# SUSQUEHANNA AREA REGIONAL AIRPORT AUTHORITY HARRISBURG INTERNATIONAL AIRPORT

# HIA WINTER ROADWAY SNOW REMOVAL BID

#### ADDENDUM ONE

Addendum No. 1 Dated: September 7, 2023

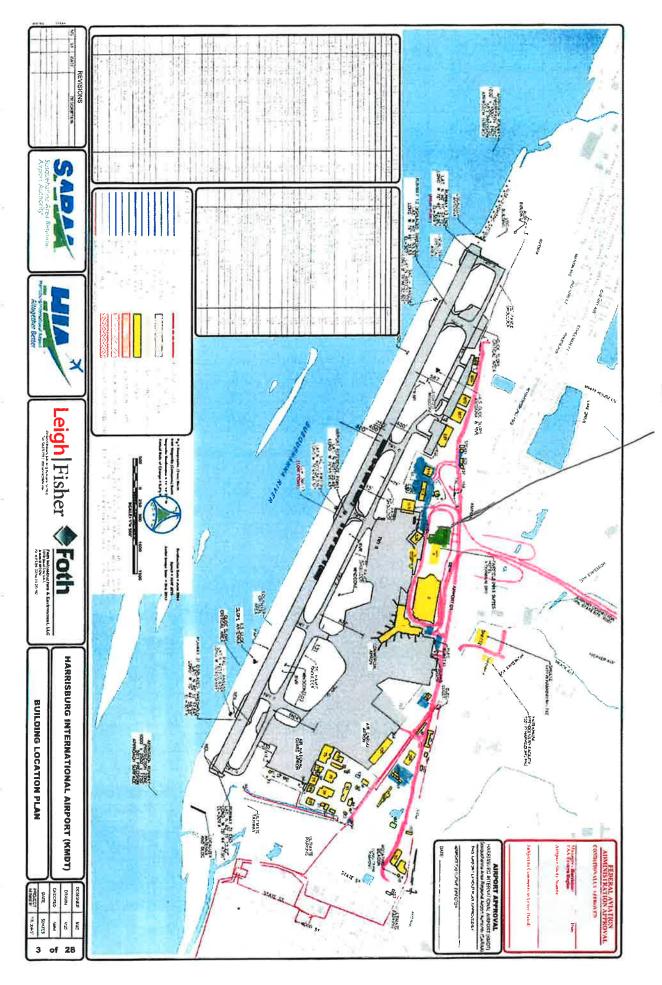
Inclusion of employee parking lot: The employee parking lot just to the west side of the hotel is included in the responsibility of the successful bidder to remove snow. Total square footage of this parking lot is 92,125 sq. feet. Please see outline map of airport complex.

Revised outlined picture of are of terminal ramp where snow will be removed attached to this addendum.
